**Before the
FEDERAL COMMUNICATIONS COMMISSION
Washington, DC 20554**

In the Matter of)	
)	
Massachusetts Institute of Technology)	ET Docket No. 19-89
Request for Waiver of Part 15 Ultra-Wideband)	
Rules for WiTrack Medical Device)

REPLY COMMENTS OF WI-FI ALLIANCE

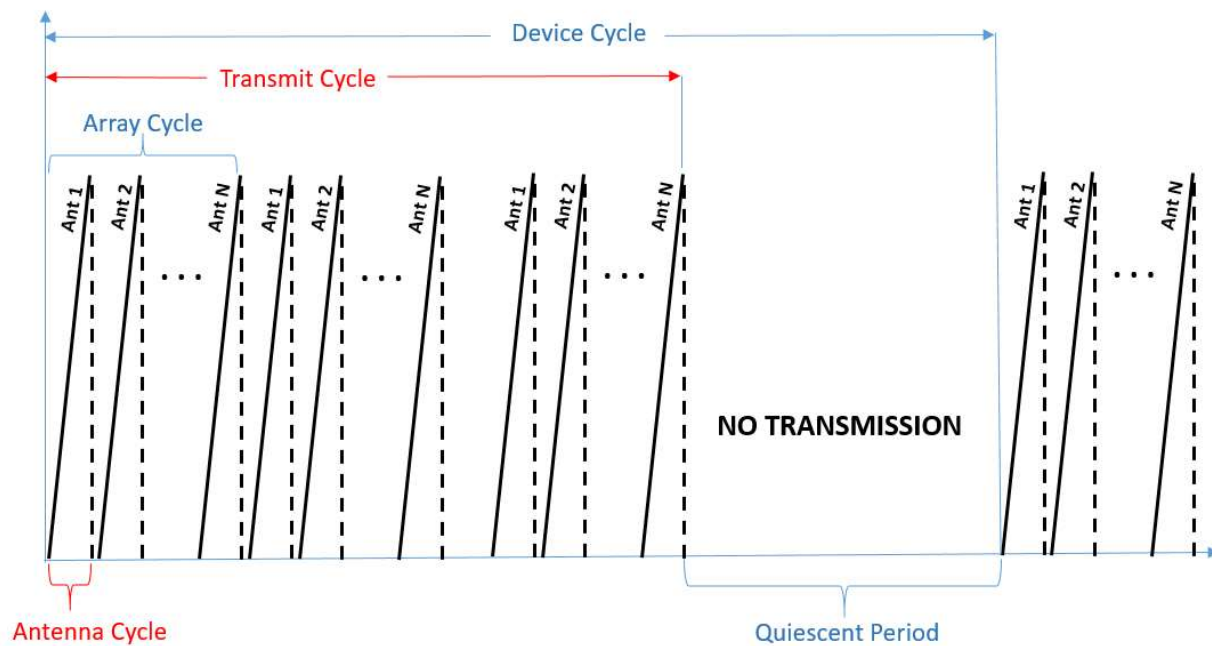
MIT's requested waiver is intended to enable "RMS measurements to be done with the swept frequency function active and **the averaging time being set to a full cycle including quiescent time during gating off.**"^{5/} As Wi-Fi Alliance understands it, this means that using a very large quiescent time within the Device Cycle, the WiTrack system might use high energy during short-burst transmissions. Further, WiTrack devices—in their monitoring role—would apparently operate these Device Cycles on a 24/7, always-on basis. This may disturb the operation of RLAN devices, for example, upsetting the automatic gain control of typical RLAN transmitters, if operating in close proximity. Such operational disturbances compound the effects of interference on RLANs by having an effect similar to that caused by a jammer, further impairing an RLAN receiver's ability to receive RLAN transmissions. Likewise, it is possible that RLAN devices that may transmit in the same frequency range as the WiTrack device may (if operated in close proximity) affect WiTrack measurements. The Petition includes a graphic attempting to display WiTrack array cycles and the quiescent period. For clarity, Wi-Fi Alliance

presents below its view of the transmission periods and quiet periods as well as the additional parameters necessary to assist in understanding potential coexistence issues.

To better understand and analyze coexistence, the Petition should be supplemented with the following additional parameters:

- **Transmit Cycle:** Time duration (typical and maximum) from one to a *maximum* of four Array Cycles
- **Antenna Cycle:** Time duration of the continuous sweep from 6 GHz to 8.5 GHz (or 7.8 GHz maximum for an alternative device variant), and whether this is constant and linear across the range, *e.g.*, x MHz per microsecond
- **Transmit power** (conducted power) during each Antenna Cycle, and any variation with frequency
- **Number of antennas (N)** and antenna gain

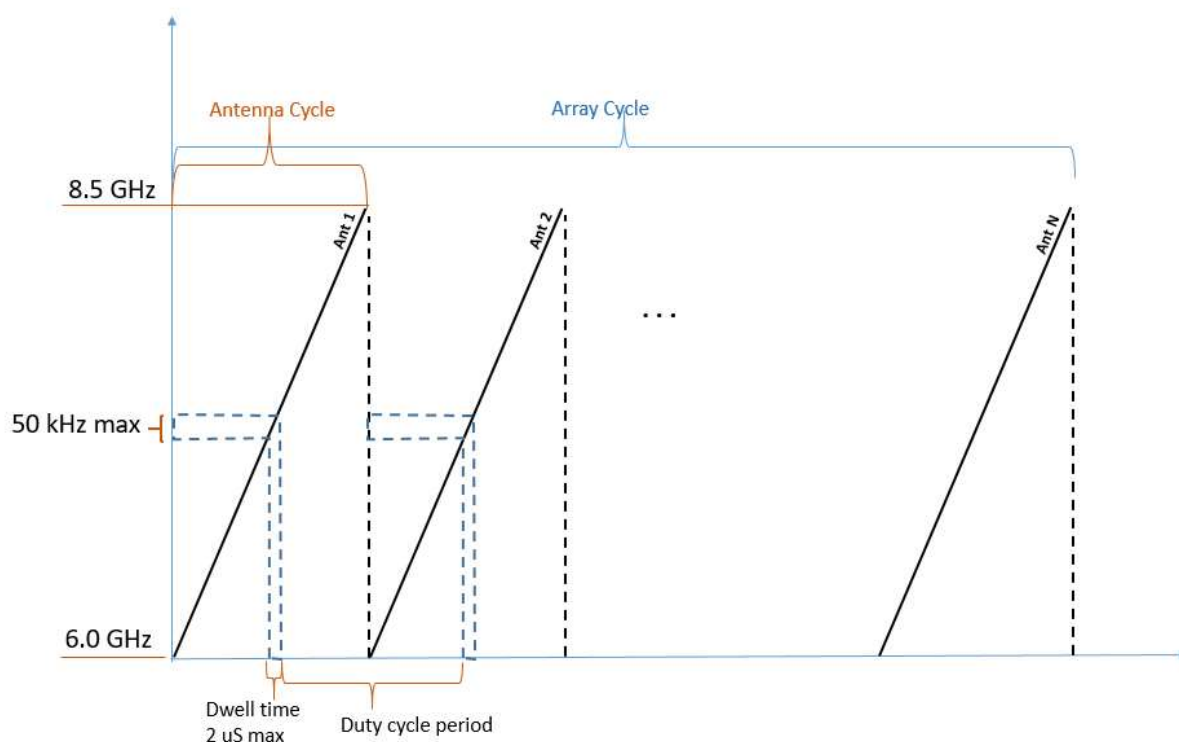
Below Wi-Fi Alliance provides an additional figure related to the descriptions and questions above, which attempts to show, in graphical form, its understanding of the WiTrack signaling operation based on the text descriptions provided by the Petitioner.

Wi-Fi Alliance would appreciate confirmation or correction of its understanding of WiTrack signaling based on the figure above.
